**Airworthiness Directive: 105**

**Date: 6/22/93**

**Subject: *Bellcrank gusset***

**Models Effected: *S-6ES, S-12, S-14 shipped after 6/20/92***

**FIGURE 1**

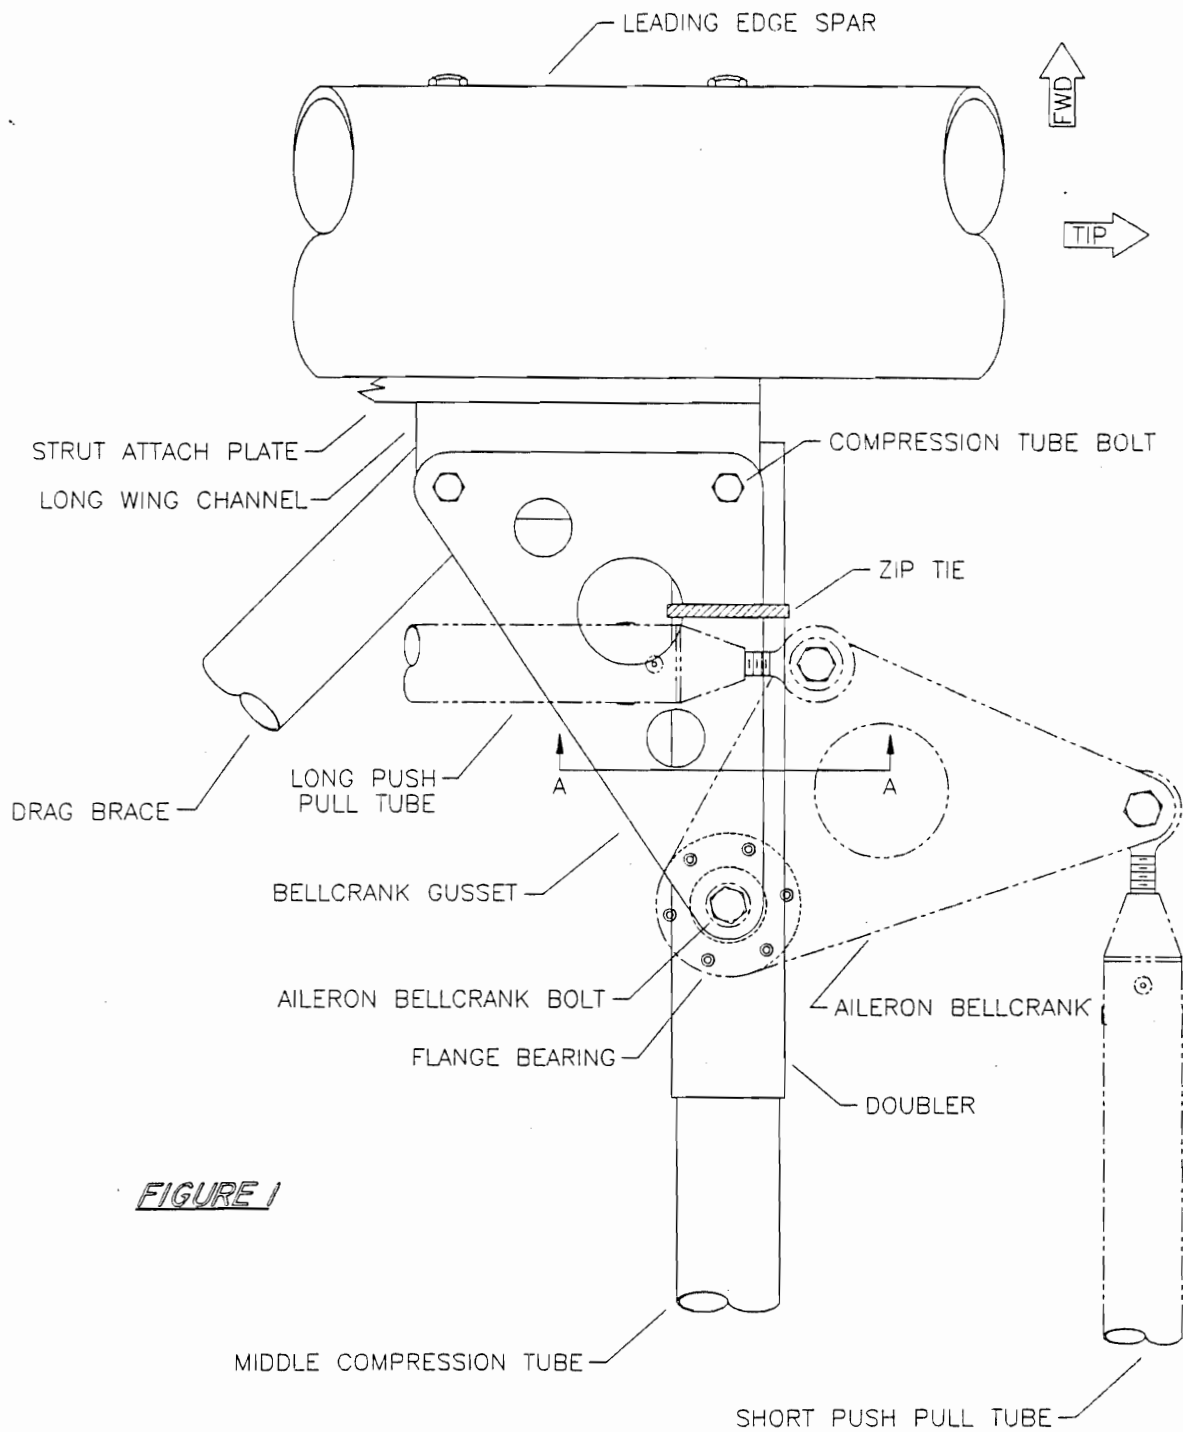
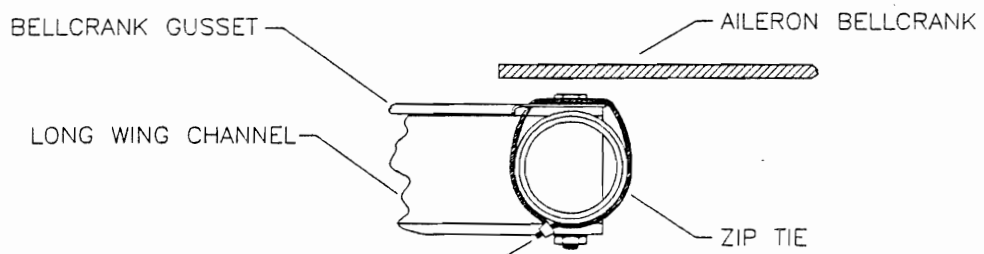
Improper assembly of the bellcrank gusset (CS-BELGU-LH/RH) may result in jamming the aileron. The gusset will have a tendency to bow upward if forced to fit between the compression tube and aileron bellcrank bolt. Proper assembly has the 1/4" hole drilled into the gusset by transfer once in place. To assure against aileron jam by gusset interfering, a plastic zip tie can be installed as per figure 1. and prescribed procedure below.

The procedure to install the zip-tie:

1. Unzip the inspection port closest to the aileron bellcrank and inspect the gusset.
2. Detach the aileron push pull tube from both ends.  
(HINT: count the number of turns when detaching the push pull tube so that you don't have to rig the aileron again when reinstalling.)
3. Get one mid size zip tie.
4. Pass your hands through the aileron push pull tube opening and the inspection port.
5. Pass the tie wrap around the compression tube through the hole over the bellcrank gusset, BUT UNDER the bellcrank (see figure1.)
6. Secure the tie wrap in place and cut the access so that it will not interfere with the aileron operation. Make sure that the tie wrap locking mechanism is pointing down.
7. Reinstall the aileron push-pull tube
8. Verify that the aileron moves freely with no restrictions.
9. Zip close the inspection port.

NOTE: POSITION OF NYLON TIE WRAP LOCKING MECHANISM ON LOWER SIDE OF TUBE
